# ADDENDUM NUMBER 5

NEW LOXLEY WATER TREATMENT PLANT

FOR CITY OF LOXLEY

GMC PROJECT NO. CMOB220078(2)

**WELL - PLAN & SECTIONS**

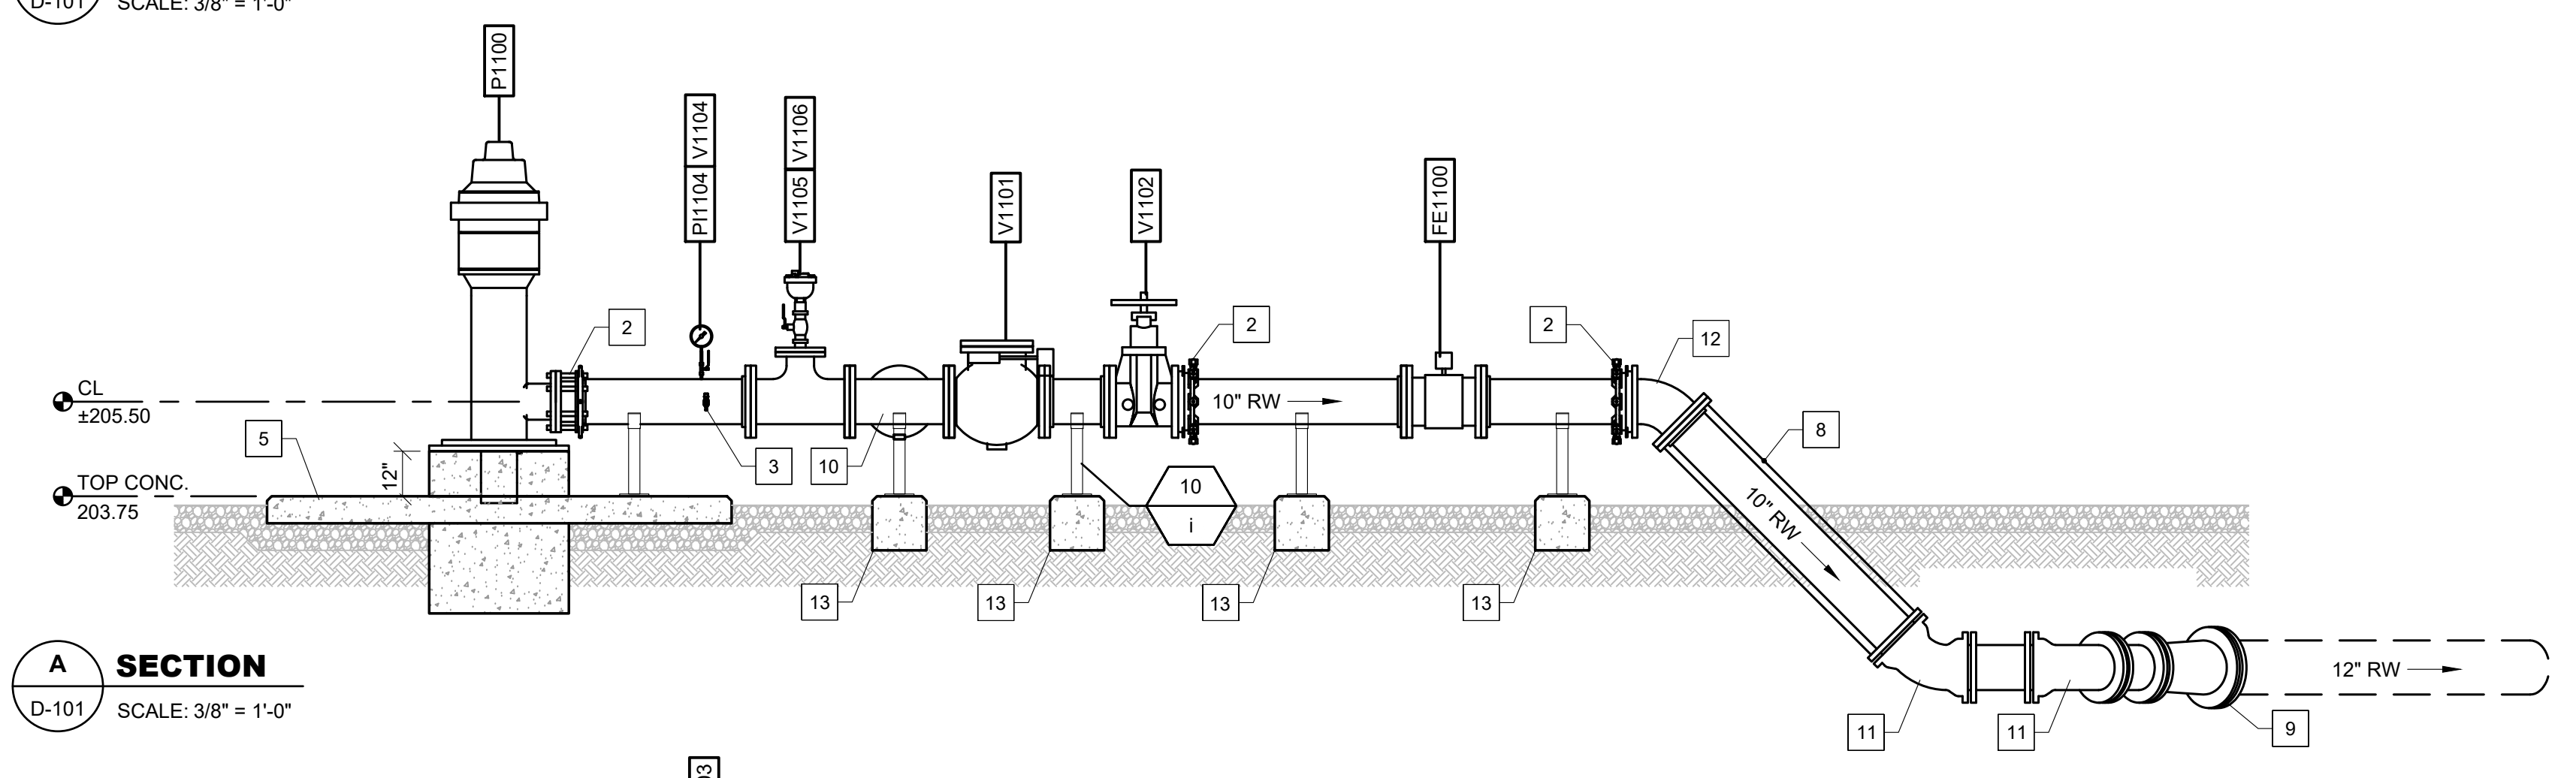
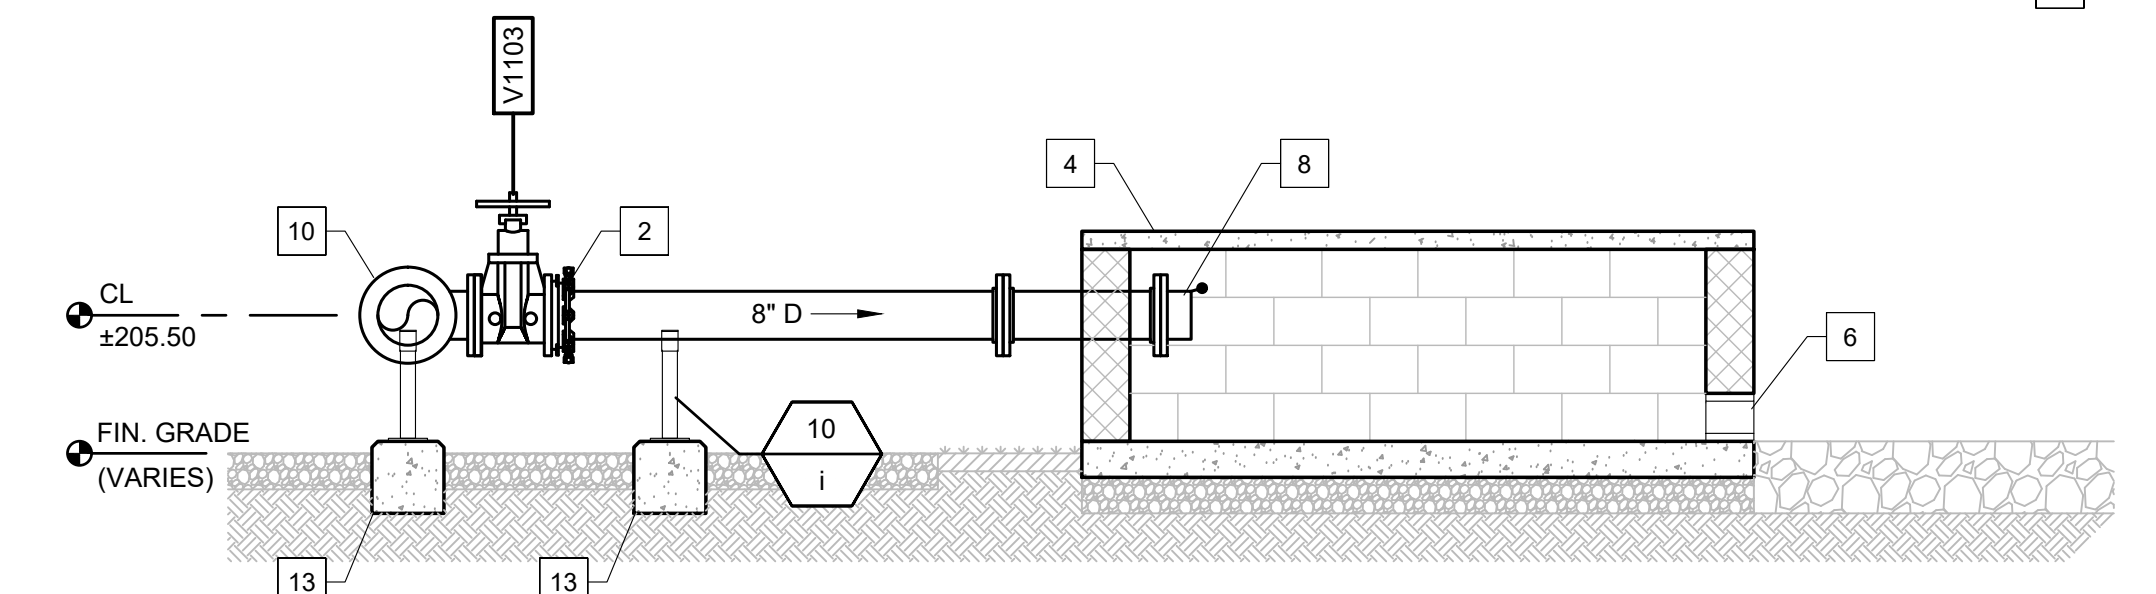
- 2.2 The size of the well pump has increased. Revised specification 33 11 13 – Water Supply Wells is included as an attachment to this addendum.
- 2.3 Due to the size increase of the well pump, several modifications have been made to the drawings and specifications. The revised drawings and specifications will be released in the next addendum. These modifications include, but are not limited to, the following:
